# Addendum

**Addendum Number:** 2.0

**Owner:** State of Iowa Department of Corrections – Clarinda Correctional Facility

**Project Name:** Clarinda Correctional Facility – Kitchen & Laundry

1 FOODSERVICE EQUIPMENT PLAN - AREA 3
1/4" = 1'-0"

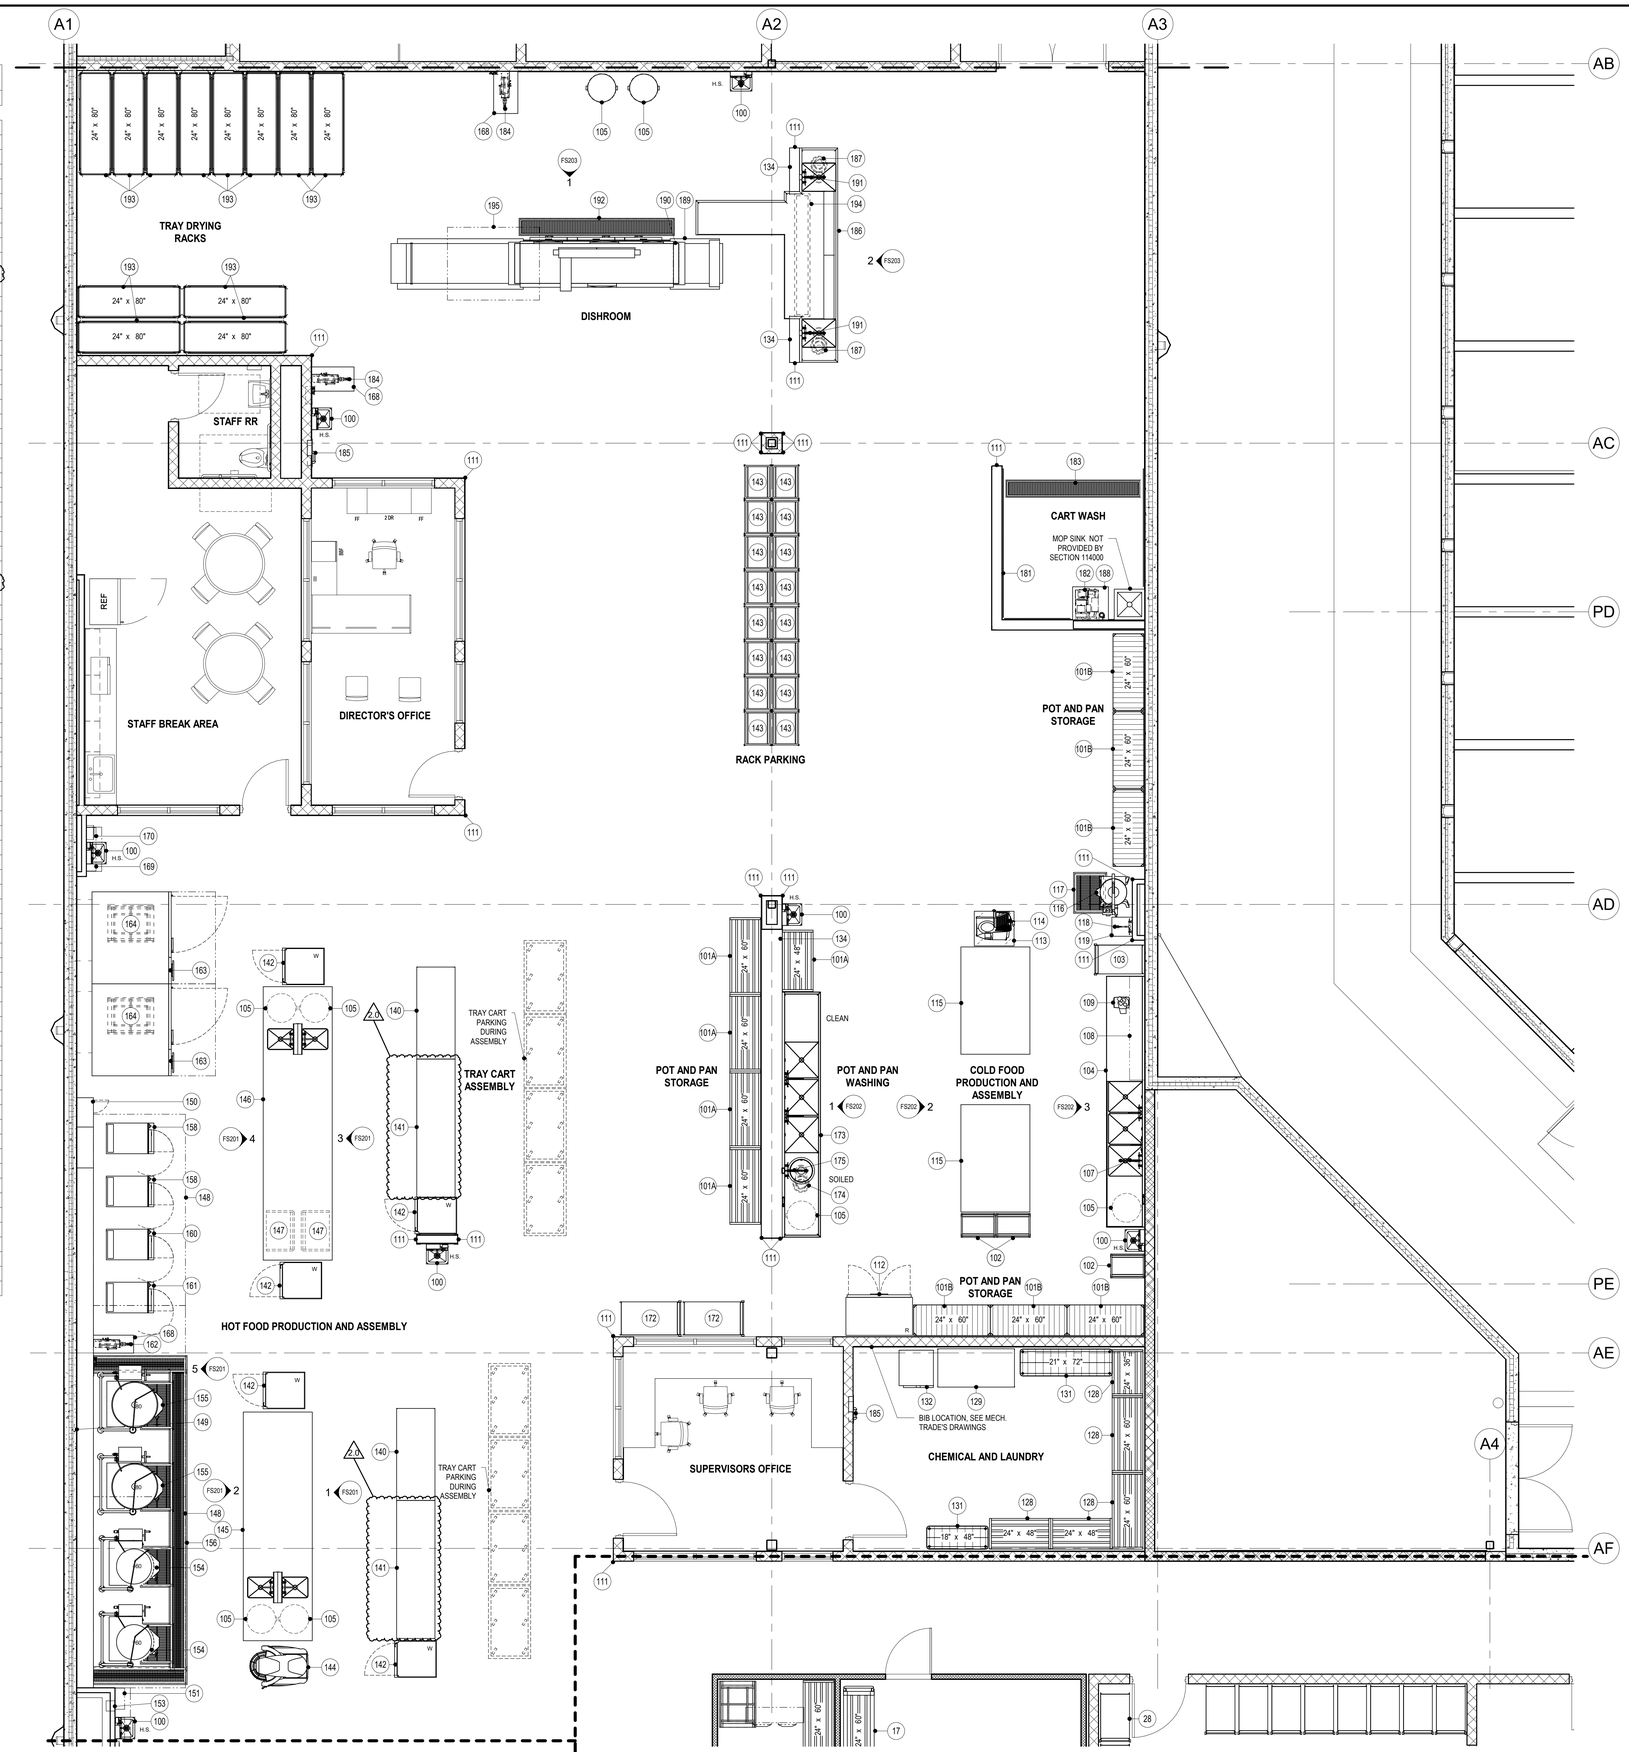
Item No. 3. FS103 – FOODSERVICE EQUIPMENT PLAN AND SCHEDULE - AREA 3
Reference Foodservice Equipment Plan – Area 3

1. **REVISE** drawings to reflect a 108" x 30" Mobile Workcounter.

3 ITEM 77 - WORKCOUNTER 1
1/2" = 1'-0"

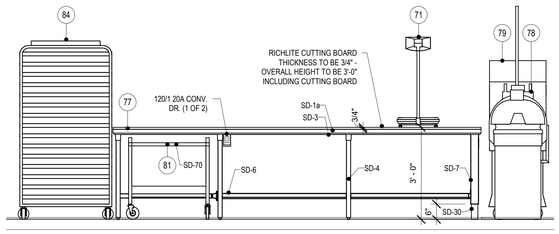
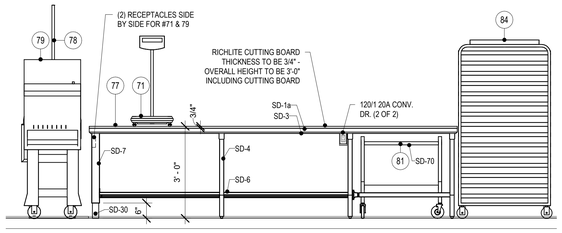
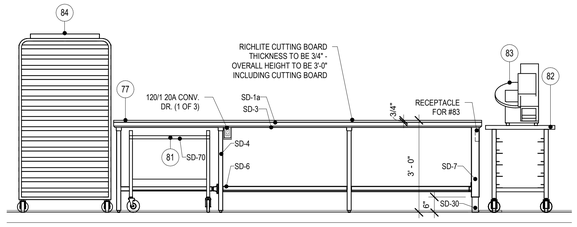
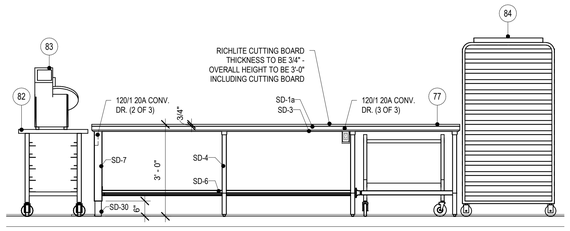
Item No. 4. FS200 – FOODSERVICE EQUIPMENT ELEVATIONS AND SECTIONS
Reference Foodservice Elevations views 3, 4, 5 and 6.

1. **REVISE** drawings to include additional details for fabrication for (2) Item 77 – Workcounter
